UNITED STATES PATENT AND TRADEMARK OFFICE

APPLICATION NO.	FILING DATE	FIRST NAMED INVENTOR	ATTORNEY DOCKET NO.	CONFIRMATION NO.
10/581,623	03/20/2007	Viktor Reis	09244W-US	5395
30680 7590 12/24/2009 DEERE & COMPANY ONE JOHN DEERE PLACE MOLINE, IL 61265				
EXAMINER				
AUNG, SAN M				
ART UNIT		PAPER NUMBER		
3657				
MAIL DATE		DELIVERY MODE		
12/24/2009		PAPER

Office Action Summary

DETAILED ACTION

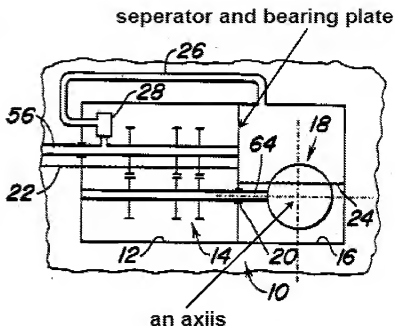
the differential assembly comprises a ring gear (16, 18, Column 2, Lines 1-3, Figure 1), and the ring gear rotates about an axis (Attached figure);

the second gearbox section comprises a bearing plate defined by a plane (Attached figure); and

the axis and the plane are parallel to one another (Attached figure and figure 1).

As per claim 13, Marquart discloses the separator (Attached figure) is mounted to at least one of the first and second gearbox sections (Attached figure and figure 1), and the separator extends from the base of the gearbox arrangement up to at least the height of a gearbox shaft (Attached figure and figure 1).

a separator (Attached figure) comprising a return (20), wherein the separator is mounted to at least one of the first and second gearbox sections (Figure 1), and the separator extends from the base of the gearbox arrangement up to at least the height of a gearbox shaft (Figure 1);
